Access Compliance Report

Public Rights-of-Way

(Curb Ramps)

Intersection ID: 51443	Main Street: SHARON_RD	Cross Street: ASHLEY_PARK_LN	Location: NW
ADA ID: 712C85DC999A	Ramp Type: Directional1	Initial Pass/Fail: Fail	Overall Compliance: No
		Severity Score: 12.5

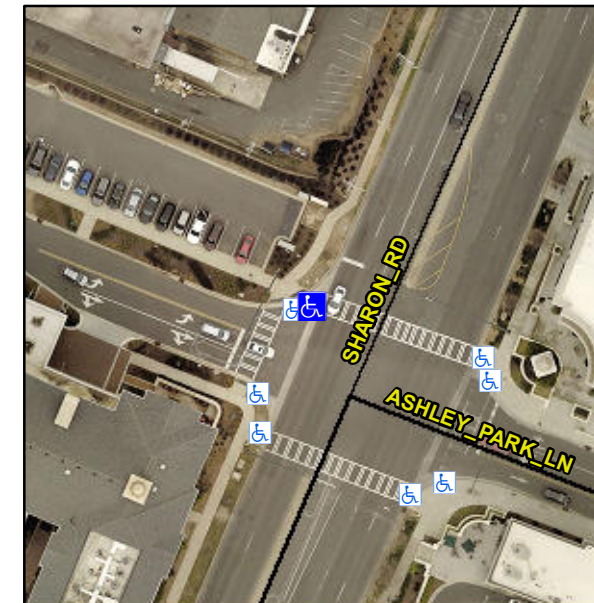
Compliance	Description	Data	Compliance	Description	Data
N/A	Ramp Length (in)	49.0	N/A	Grade Break?	N/A
Yes	Ramp Width (in)	83.0	N/A	Grade Break Slope (%)	0.0
Yes	Ramp Slope (%)	5.1	N/A	Grade Break XSlope (%)	0.0
No	Ramp XSlope (%)	5.3			
N/A	Flare Type LT	N/A	N/A	Flare Type RT	N/A
N/A	Flare Slope LT (%)	N/A	N/A	Flare Slope RT (%)	0.0
N/A	Flare Traversable LT?	N/A	N/A	Flare Traversable RT?	N/A
N/A	Landing Length (in)	0.0	N/A	DWS Provided?	N/A
N/A	Landing Width (in)	0.0	N/A	DWS Contrast?	N/A
N/A	Landing Slope (%)	0.0	N/A	DWS Length (in)	N/A
N/A	Landing X Slope (%)	0.0	N/A	DWS Full Width?	N/A
N/A	Landing Curb? (Y/N)	N/A	N/A	DWS Offset LT (in)	N/A
N/A	Shared Landing?	N/A	N/A	DWS Offset RT (in)	N/A
N/A	Gutter Ponding?	0.0	N/A	Gutter Slope (%)	N/A
N/A	Gutter Lip Ht (in)	0.0	N/A	Gutter X Slope (%)	N/A
N/A	Painted X Walk1?	Yes		Road Slope (%)	1.5
	X Walk 1 Direction	To E		Road X Slope (%)	0.6
	X Walk 1 Width (in)	111.0		Clear Space?	N/A

X Walk 1 Slope (%)	1.5	N/A	Clear Space to XWalk (in)	N/A
	X Walk 1 X Slope (%)	0.6	N/A	Storm Grate/Utility Hazard?	N/A
N/A	Ramp inside XWalk1?	Yes		Storm Grate/Utility Type	
N/A	Any Obstructions?	N/A			N/A
	Obstruction Type		Yes	Surface Condition? (G/P)	Good
			N/A	Curb Slope (%)	9.6

Remove & Replace Entire Ramp.

R304.5.3
